March 15, 2023

Re: Bike Lane Design in Connecticut Avenue Deckover and Streetscape Project

Figure 1 - DDOT Proposed Cross Section with 5' bike lanes

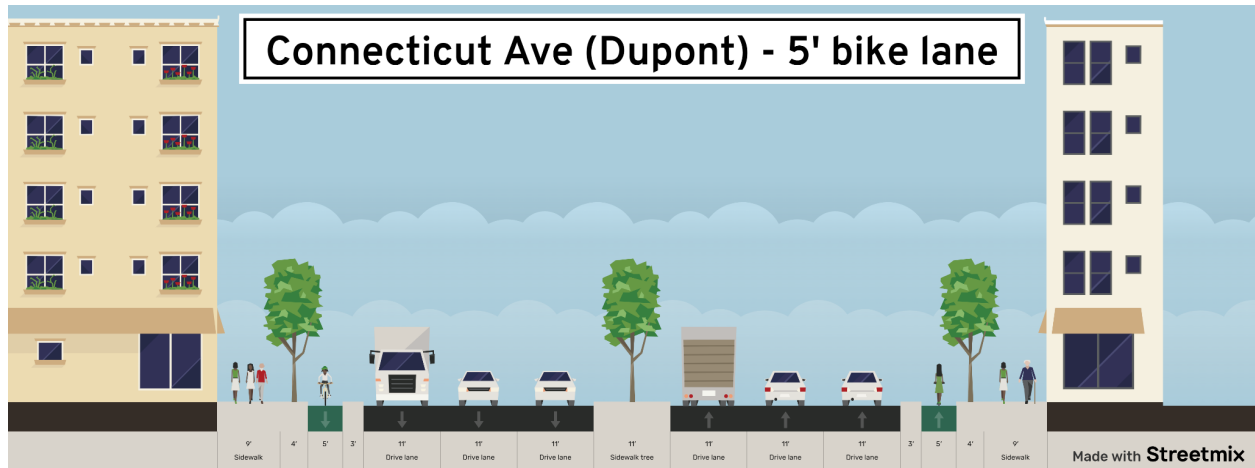
We do not find these reasons convincing and believe that DDOT's Design and Engineering Manual (DEM) and federal guidance better supports wider (7') bike lanes and narrower (10') driving lanes here. We urge DDOT to make a modest design change. Reduce the width of two driving lanes in each direction from 11' to 10' and push the bike lane curbs 2' closer to the center line (see Figure 1 and 2 for illustration). This change allows for the recommended 7' bike lanes while maintaining an 11' outside lane for buses. 10' driving lanes are supported by the DDOT DEM and ubiquitous on multi-lane roads in DC, including on Connecticut Avenue. Research shows that narrower lanes lead to more careful driving, slower speeds, and fewer crashes. This change would not modify the planned curb line and should not impact drainage so is unlikely to increase cost or add delay.

Every protected bike lane standard and design guide published in the last 10 years, including DDOT's own, agrees that a 5' wide bike lane between raised curbs is the minimum acceptable width and not recommended for high-volume corridors or on hills. Compared to a 6.5' - 7' protected bike lane, 5' bike lanes:
